Access Compliance Report

Public Rights-of-Way

(Curb Ramps)

Intersection ID: 3495	Main Street: MAPLE_VIEW_LN	Cross Street: W_W_T_HARRIS_BV	Location: SW
ADA ID: 80C92FEA2972	Ramp Type: Perp	Initial Pass/Fail: Fail	Overall Compliance: No
Severity Score: 22.5			
Codes/Mitigation Info/Possible Solution		Field Measurements/Component Compliance

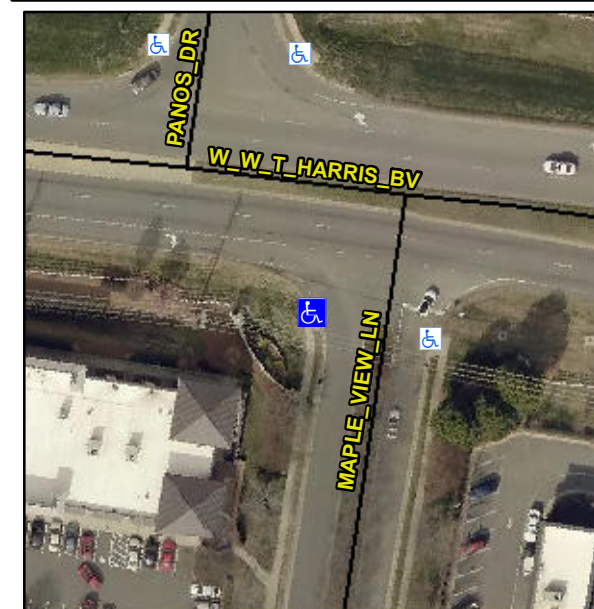
Not Found, R304.5.1, R304.2.2, R304.5.3

Compliance	Description	Data	Compliance	Description	Data
N/A	Ramp Length (in)	51.0	No	Ramp Slope (%)	10.2
No	Ramp Width (in)	47.0	No	Ramp XSlope (%)	4.4
N/A	Flare Type LT	N/A	N/A	Flare Type RT	N/A
N/A	Flare Slope LT (%)	N/A	N/A	Flare Slope RT (%)	N/A
N/A	Flare Traversable LT?	N/A	N/A	Flare Traversable RT?	N/A
N/A	Landing Length (in)	N/A	N/A	DWS Provided?	N/A
N/A	Landing Width (in)	N/A	N/A	DWS Contrast?	N/A
N/A	Landing Slope (%)	N/A	N/A	DWS Length (in)	N/A
N/A	Landing X Slope (%)	N/A	N/A	DWS Full Width?	N/A
N/A	Landing Curb? (Y/N)	N/A	N/A	DWS Offset (in)	N/A
N/A	Shared Landing?	N/A			
N/A	Gutter Ponding?	N/A	N/A	Gutter Slope (%)	N/A
N/A	Gutter Lip Ht (in)	N/A	N/A	Gutter X Slope (%)	N/A
N/A	Painted X Walk1?	No	N/A	Painted X Walk2?	N/A
	X Walk 1 Direction	To E		X Walk 2 Direction	N/A
N/A	X Walk 1 Width (in)	N/A	N/A	X Walk 2 Width (in)	N/A
	X Walk 1 Slope (%)	5.6		X Walk 2 Slope (%)	N/A
	X Walk 1 X Slope (%)	4.8		X Walk 2 X Slope (%)	N/A

Remove & Replace Entire Ramp.
